RICHMOND AMERICAN HOMES JOB#33060083

PLOT PLAN LOT 43

SUBDIVISION: THE GLEN AT WIDEFIELD FILING NO. 12

ADDRESS: 7242 DWARF CLOVER COURT

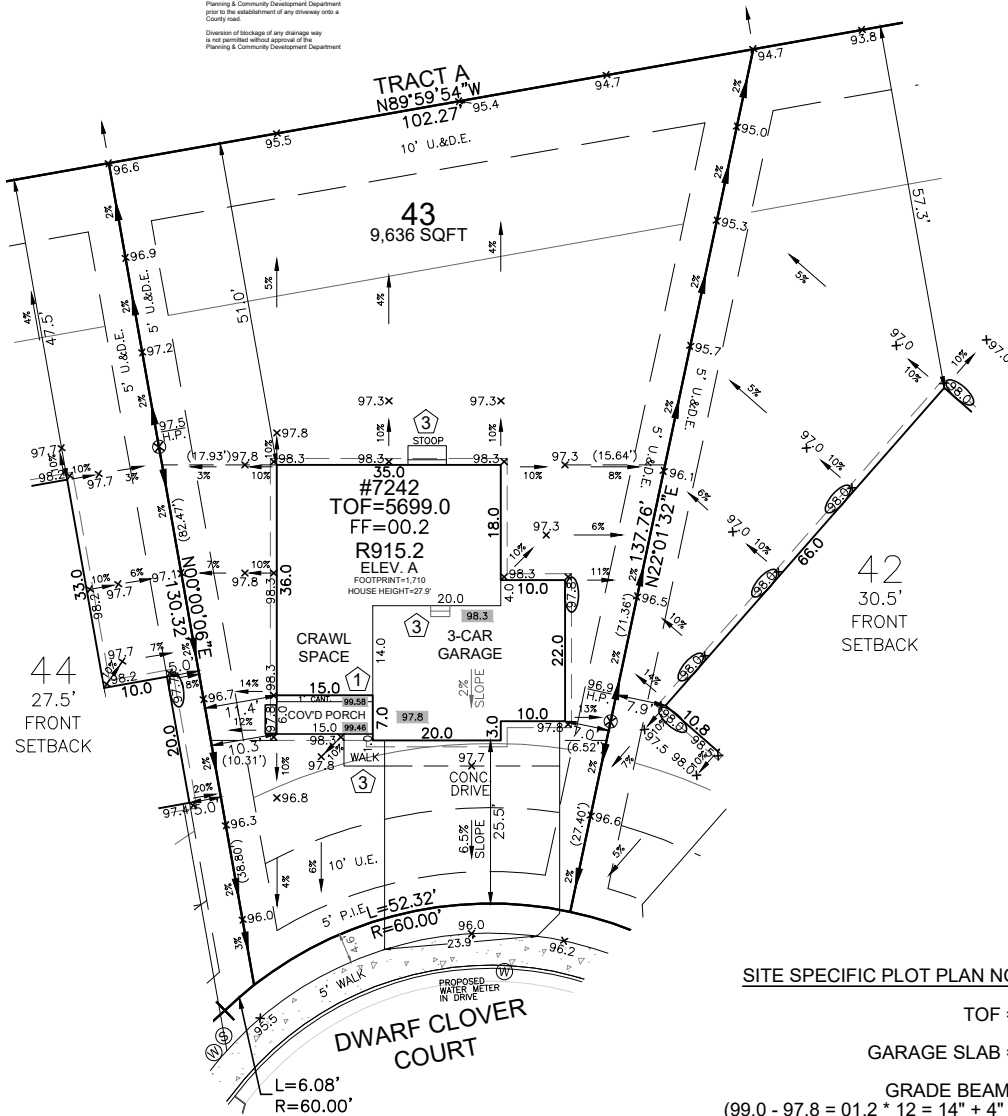
Applicant did not provide evidence to show that the recommendation below has been followed. As in other filings of The Glen at Widefield Sub, each individual lot to be investigated by the city owner's Geotechnical Engineer of Record for final foundation parameters and recommendations.

It is the owner's responsibility to coordinate with easement holders to avoid impact to utilities that may be located in the easements.
